Delaware County Regional Planning Commission

AGENDA

Thursday, September 26, 2024 at 6:00 PM
Byxbe Campus Conference Room, 1610 State Route 521,
Delaware, Ohio 43015

RPC#30-24zon
Bandit Properties LLC
 6.74 acres / FR-1 to PCD
 Harlem Twp.

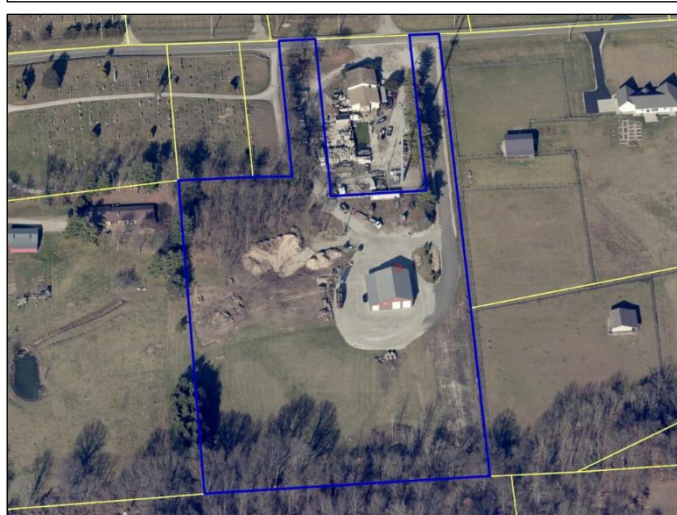
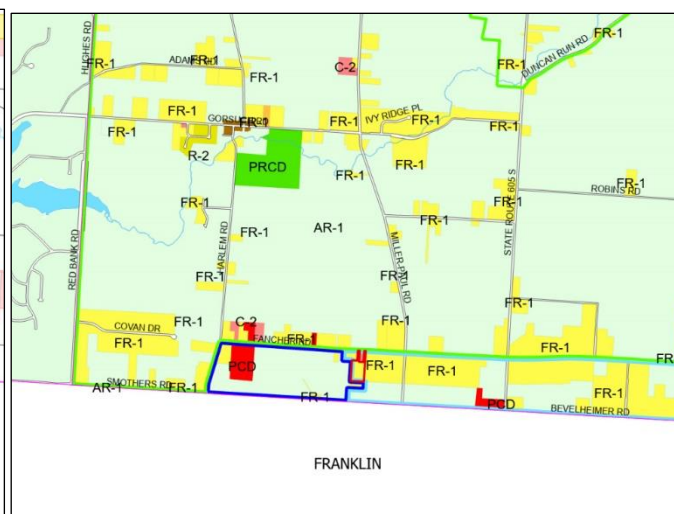
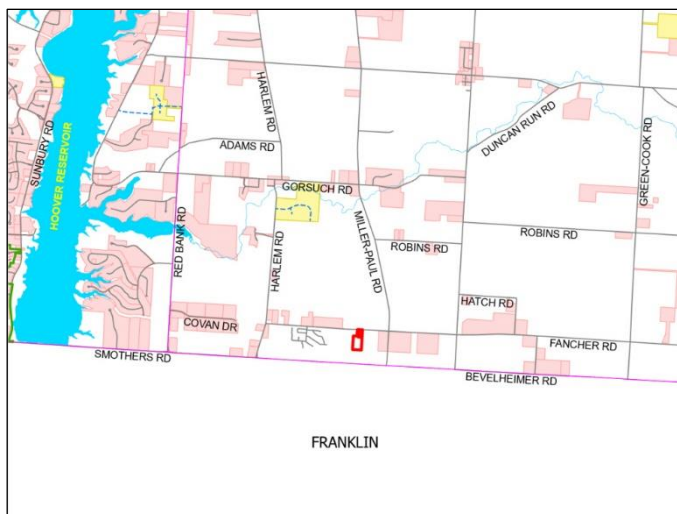
One point of ingress/egress along Fancher Road (northeast) and potential for a cross-access easement from the neighboring commercial property.

The development plan identifies a drainage tile leading from the northwest corner of the site, through the gravel parking area and terminating at the stormwater pond. A drainage plan should be reviewed and approved by the DCEO prior to Zoning Compliance approval.

Lighting will only include downcast lighting. However, a lighting plan was not submitted.

Staff Comment: Based on the majority of the site being used for outdoor storage and no easements are necessary, Staff has no concerns with this request.

Staff Comment: Provided dust is mitigated and controlled, Staff has no concerns with this request.

Staff Comment: Based on the majority of the site not being visible from Fancher Road, Staff would have no concern with this request.

- 1.) *Public Health approves the proposed on-site wastewater treatment system to ensure it can handle the proposed use;*
- 2.) *A drainage plan should be reviewed and approved by the DCEO prior to Zoning Compliance approval, and;*
- 3.) *A lighting plan should be submitted.*

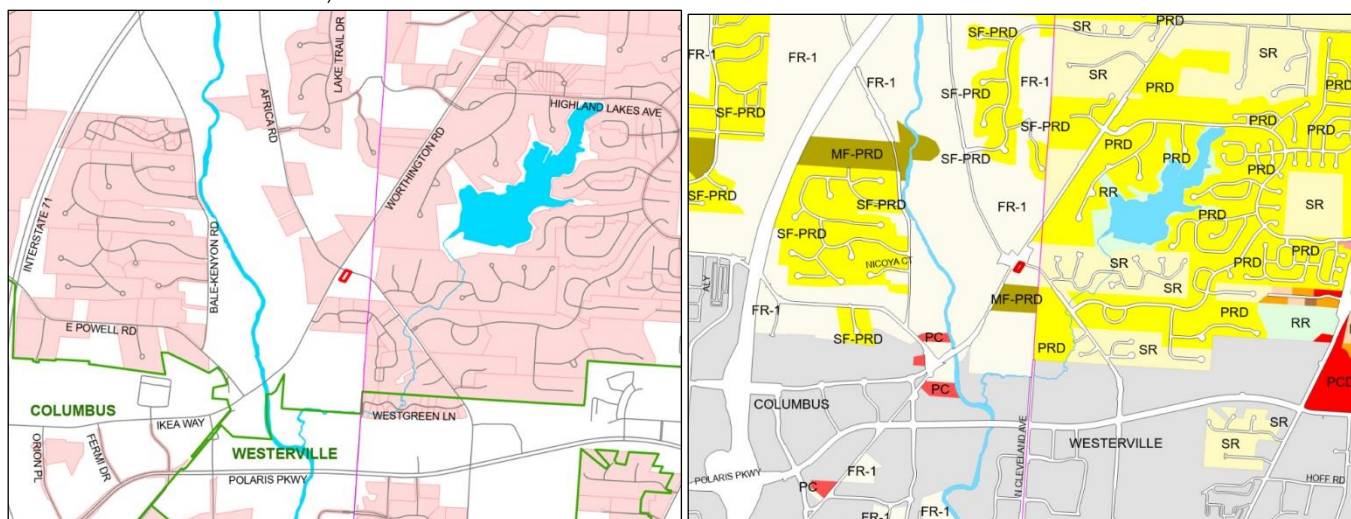
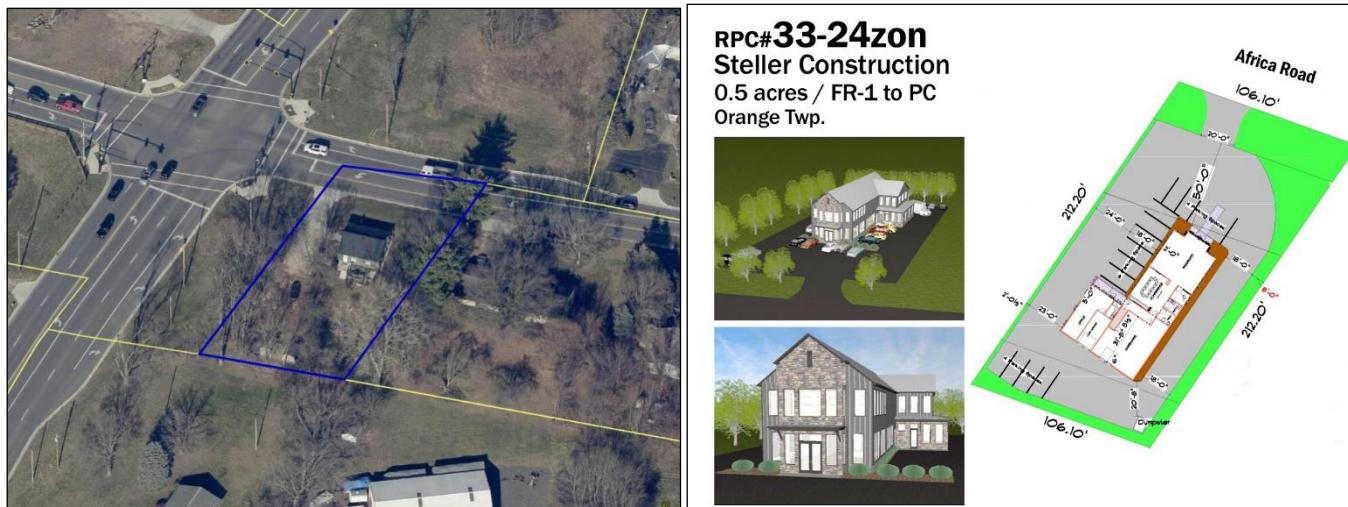
A drainage plan was not submitted. The DCEO requires that a Final Engineering Plan be reviewed for this project. Staff wonders if there is sufficient space on the site for stormwater management – underground

None proposed, but it would seem that a commercial use would request signage. If that is the case, a proposed signage plan should be provided to the township.

Staff Comment: With public sanitary sewer proposed, other necessary utility easements and a potential pedestrian path easement along Africa Road, Staff would prefer to see this development platted (potentially along with any future commercial development in this area). This is the call of the Regional Planning Commission.

Staff Comment: Staff recommends using parking pavers in some parking spaces, tree islands on the east and west of the northern parking spaces and add greenspace between the dumpster and the southern parking spaces to ensure the minimum divergence is requested, or potentially not needed.

Staff Comment: Staff has no concerns with this request. However, the applicant should be aware that if needed parking spaces expand into non-striped spaces a zoning violation may be initiated by the Township.

Staff Comment: Staff is unaware of any proposed commercial use to the south. However, the proposed landscaping as shown on the site plan may be acceptable based on the proposed use. It may be of note that the property to the south was purchased by “SGN 2 REALTY, LLC” in 2022 and based on aerial imagery the site is potentially being used for commercial purposes currently.

Staff Comment: Staff has no concern with this request based on the lighting plan submitted.

- 1.) Driveway should be moved as far to the east as possible;
- 2.) Preliminary drainage plan should be submitted for comment;
- 3.) Consider installing a sidewalk along Africa Road ROW as approved by the DCEO; and
- 4.) Consider using parking pavers in some parking spaces, tree islands on the east and west of the northern parking spaces and add greenspace between the dumpster and the southern parking spaces to ensure the minimum divergence is requested, or potentially not needed. Consider flipping the layout to address these issues and accommodate the driveway relocation.

RPC#34-24zon
Bavelis Zenios Dvlpt.
Evans Farm - Ross PRD
 19.02 ac. / PRD Dev. Plan Amendment
 Berlin Twp.

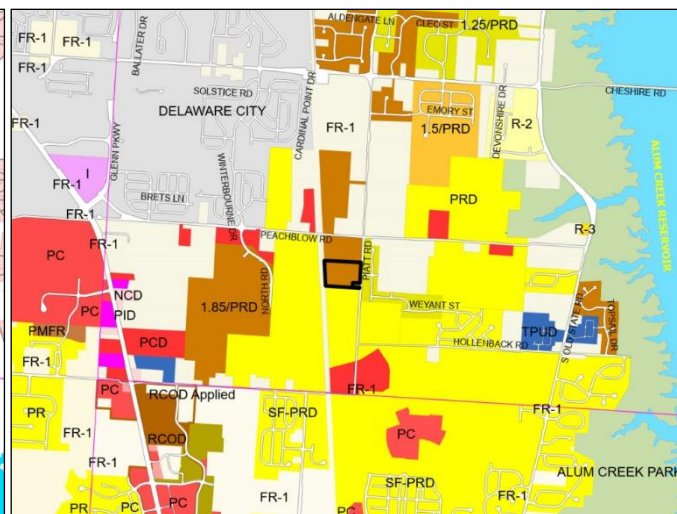
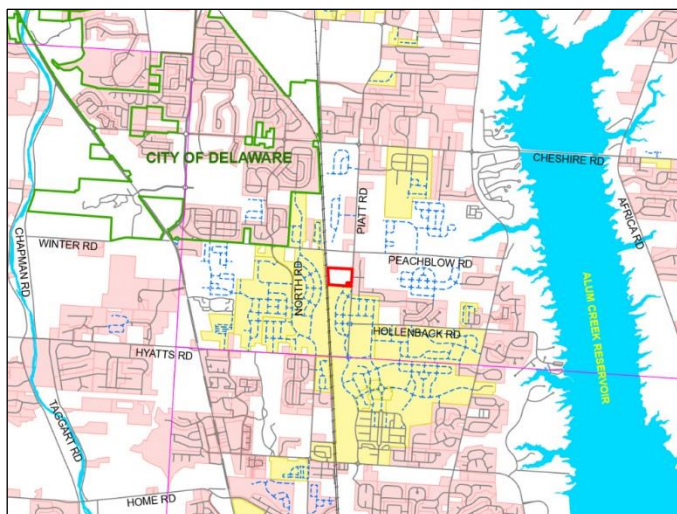
This development is providing paths/connections and street stubs to the south. However, the majority of the open space is not usable as it generally accommodates for the stormwater ponds. There are also numerous divergences and a building design which does not meet the previously accepted design style of Evans Farm. The density of 3.63 gross and 3.65 net exceeds the density in the Comp Plan. Additionally, recent park and trail planning in the township has identified the need for a multi-used path along the railroad.

A drainage plan was not submitted. A detailed stormwater management report must be submitted to the DCEO during Preliminary Engineering.

A lighting plan was not submitted. Street lights will be provided and must follow those approved for overall

Staff Comment: Staff has no concerns with this request as the development is bordered by the elementary school to the north, railroad tracks to the west and future Evans Farm residential development to the south, which is already zoned PRD. More importantly, the development is buffered from Piatt Road, similar to other developments in the area. The western lots are deeper and could include additional setback, including the multi-use path noted in the report.

Staff Comment: Staff does not support this request as meeting the required density would assist in meeting other zoning requirements that are not being met (open space within this project, setbacks, perimeter, lot size).

Staff Comment: As indicated with the density divergence, Staff does not support this request but does note that open space is distributed throughout the entire Evans Farm subdivision and it is unknown what is happening directly south of this site.

Staff Comment: This is a divergence that has been approved in the Orange Township portion of Evans Farm and is an important element in creating a walkable streetscape. Staff recommends this divergence be approved.

Staff Comment: Staff agrees with the concept of Evans Farms mixed-use development as described in this Development Text, which did require divergences for the overall development. However, this site is over 1.5 miles north of what is the Evans Farm Town Center. The previous plan for this site proposed larger lots that were a transition to Oldfield Estates and Piatt Meadows subdivisions just to the east. Again, similar to other requests, if these and other standards are met, the development would be closer to the approvable density.

Staff Comment: Staff is not opposed to smaller lot sizes for this subdivision, especially if the required open space (distributed throughout) is provided. However, there is a rather large discrepancy in lot sizes with this request, which should be amended. Larger lot sizes will assist in reducing other requested divergences.

Staff Comment: Staff believes the lot width should be increased to assist in reducing other necessary divergences.

Staff Comment: As noted in this report, based on the home renderings submitted the applicant should consider including more significant architectural features including covered porches on homes. It appears porticos are provided on some of these homes.

Staff Comment: Staff is unclear why this divergence is requested as it appears the standard is met.

Staff recommends **Denial** of the rezoning request by Bavelis Zenios Development for a development plan approval to the DCRPC, Berlin Twp. Zoning Commission and Berlin Twp. Trustees.

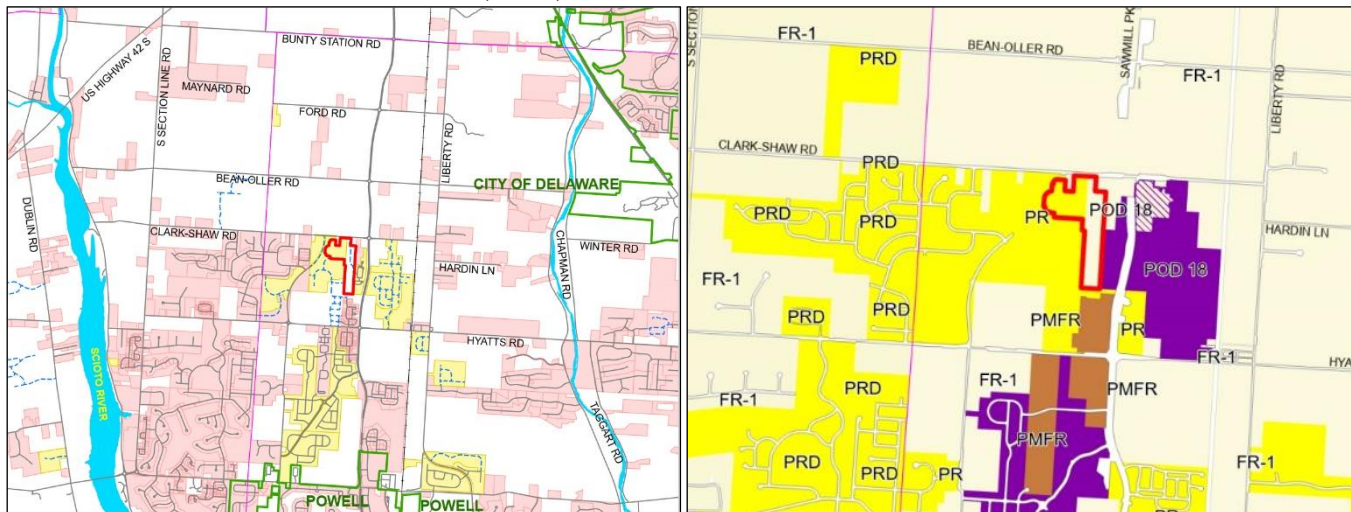
Staff acknowledges that the Zoning Resolution allows for a gross density of 6 du/net acre with a minimum required 20% open space. However, the Comprehensive Plan recommends a much lower density, which is exceeded (4.72 du/net acre), and new higher-density multi-family developments are not supported in the plan. Staff acknowledges that except for the Rosewood project, which was approved as part of a large overlay, the general development character of this area is single-family and single-family condos at densities closer to 2 units per gross acre. Additionally, three access points are recommended and only one point of ingress/egress is provided; and this access point is a private drive that will serve three total developments (the single-family condos, the townhouse area, and Rosewood Village MF (362 total units)).

A drainage plan was not submitted. There are two stormwater ponds on site, one to the north and one to the south. The applicant stated that drainage will be reviewed by the DCEO during Final Engineering.

While condominiums are exempt from the platting requirement, staff believes that if the site is developed as proposed, the townhomes area would need to be on its own parcel, raising questions of how that would be accomplished since the road is private and there is no proposed right-of-way. Staff recommends platting the area, allowing these private easements to be located in a single recorded document. The single-family condo area could remain one large “lot” with easements as has been encouraged and approved in other locations.

Staff Comment: Staff has no concerns with this request as other developments in the area have similar, reduced setbacks.

Staff Comment: Staff has no concerns with this request as other developments in the area have similar, reduced setbacks.

Staff Comment: Because this relates to the overall development and not a separate building parcel line, staff concurs with this request, as long as maintenance of the pond is described in the development text and condo description.

Staff Comment: Staff agrees that a 30 ft. setback may be appropriate with this development as it is essentially private, with the only shared access point being with the proposed apartments, and surrounded by open space.

Staff Comment: Staff recommends considering the use of permitted materials on the front of the homes and potentially using vinyl on the sides and rear.

Staff Comment: Staff has no concerns with this request. The proposed free-standing sign detail can be found on exhibit D-2.

Staff Comment: The development only fronts on private drives, which ultimately gain access from Clark-Shaw Road. If supported by the DCEO and other applicable agencies, it's recommended that at least one additional access point be provided along Steitz Road, or the emergency access drive that connects to Clarkshaw Reserve be made full access.

Staff believes the mix of single-family and townhomes could be a positive addition in this area, and the general design is not completely out of character with the current development going on in the area. However, with the discrepancies to the Comprehensive Plan (density, building types, frontage/access on a public road), it appears the development could be redesigned to align more with those recommendations. One option would be to lower the density by developing the townhome area with additional single-family detached units, bringing the overall density down to a level more consistent with development to the west.
